Re: Comments to the Fresno County Board of Supervisors
Regarding Conditional Use Permit Application 3528

We write on behalf of Grand Petroleum Inc., (“Grand Petroleum”) to further comment on Initial Study 7104 and the Mitigated Negative Declaration prepared by the Fresno County Planning Department (“County”) for the Conditional Use Permit Application 3528 (“CUP 3528”). The Applicant for CUP 3528, Shawn Shiralian, seeks to construct a large highway travel center, including a gas station, truck stop, restaurant, shower facility, and service center, at the northwest quadrant of the Interstate 5/Nees Avenue interchange in Fresno County, California (the “Project”). On August 18, 2017, we submitted written comments on the Initial Study to the Planning Commission. Additionally, we provided oral comments and a copy of our written comments to the Planning Commission at their meeting on August 24, 2017. We have enclosed a copy of the August 18, 2017 materials with this letter and incorporate these materials with this comment letter.

FIGURE 5 – SUNDAY PEAK-HOUR PROJECT TRAFFIC VOLUMES

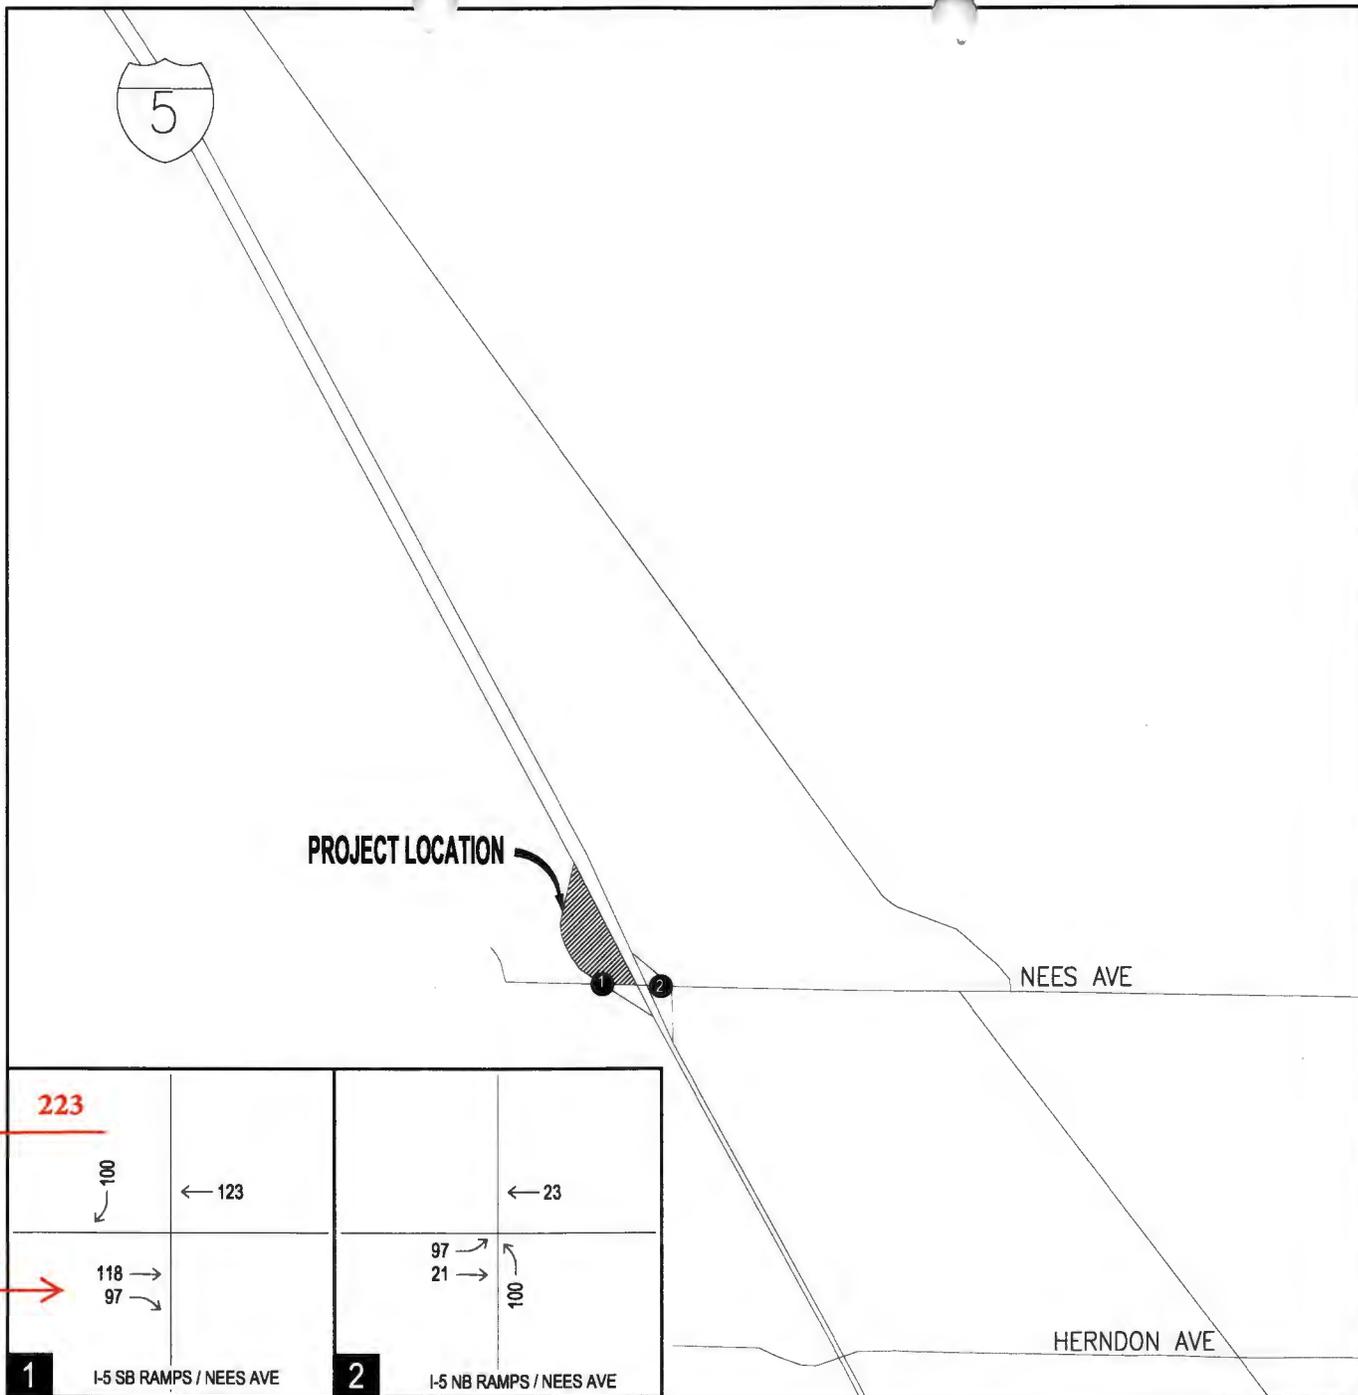
4. **Project Traffic Assignment is Flawed** – Figure 5 in the PEG study illustrates the assignment of Project-generated trips to the study intersections. For ease of reference, that figure is presented here as Attachment C, with the total peak-hour volume of Project-generated traffic west of the Nees Avenue/I-5 Southbound Ramps intersection noted in red. As shown there, Figure 5 shows 223 westbound project trips traveling toward the Project site and 215 eastbound trips departing the Project site.

However, PEG Table 6 (p. 8), which summarizes the Project trip generation estimate employed in the analysis, shows that the Project is estimated to generate 228 inbound trips and 222 outbound trips. Consequently, the Project traffic assignment values shown in Figure 5 represent a shortage of 5 inbound trips and 7 outbound trips. This is summarized in Table 1 below.

Source	Project Trips		
	In	Out	Total
PEG Table 6 ²	228	222	450
PEG Figure 5 ³	223	215	438
Difference	5	7	12
